Access Compliance Report Public Rights-of-Way (Curb Ramps)

Main Street: NACIENTE_ST Cross Street: RASTRO_ST Location: N

ADA ID: RPRK211116141608 Ramp Type: Type 4 - Parallel Initial Pass/Fail: Fail Overall Compliance: No Severity Score: 16

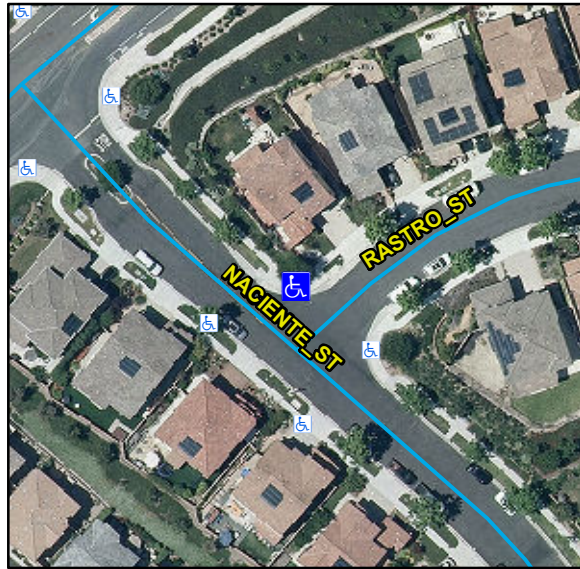
Compliance	Description	Data	Compliance	Description	Data
N/A	Ramp Length LT (in)	87	N/A	Ramp Length RT (in)	64
Yes	Ramp Width LT (in)	52	Yes	Ramp Width RT (in)	52
No	Ramp Run Slope LT (%)	8.9	Yes	Ramp Run Slope RT (%)	1.4
No	Ramp Cross Slope LT (%)	2.7	Yes	Ramp Cross Slope RT (%)	0.4
N/A	Landing Present	N/A	N/A	DWS Provided	N/A
N/A	Landing Length (in)	N/A	N/A	DWS Contrast	N/A
N/A	Landing Width (in)	N/A	N/A	DWS Length (in)	N/A
N/A	Landing Run Slope (%)	N/A	N/A	DWS Full Width	N/A
N/A	Landing Cross Slope (%)	N/A		DWS Offset Type	N/A
N/A	Landing Movement Obstructed?	N/A	N/A	DWS Offset Left (in)	N/A
	Landing Movement Type	N/A	N/A	DWS Offset Right (in)	N/A
N/A	Landing Shared	N/A			
N/A	Clear Space	Yes			
N/A	Clear Space To Crosswalk (in)	N/A			
N/A	Marked Crosswalk 1	No	N/A	Marked Crosswalk 2	No
	Crossing 1 Direction	SW		Crossing 2 Direction	SE
	Marked Crosswalk 1 Width (in)	N/A		Marked Crosswalk 2 Width (in)	N/A

N/A	Ramp Inside Crosswalk 1	N/A	N/A	Ramp Inside Crosswalk 2	N/A
	Crossing 1 Slope (%)	3.3		Crossing 2 Slope (%)	1.6
	Crossing 1 Cross Slope (%)	6		Crossing 2 Cross Slope (%)	2.6
N/A	Gutter Ponding	N/A	N/A	Curb Slope	7.3
Yes	Gutter Lip Height (in)	0		Road Run Slope (%)	6.7
N/A	Gutter Run Slope (%)	N/A		Road Cross Slope (%)	1
N/A	Gutter Cross Slope (%)	N/A	Yes	Perpendicular Joint Present	Yes
Yes	Overall Surface Condition	Acceptable			
	Cross Gutter Present?	No		Spandrel Present?	No
	Replace Cross Gutter?	N/A		Replace Spandrel?	N/A

Remove & Replace Curb Ramp With Two New Directional Ramps or Equivalent.

R304.3.2, R304.5.3, STD 1115
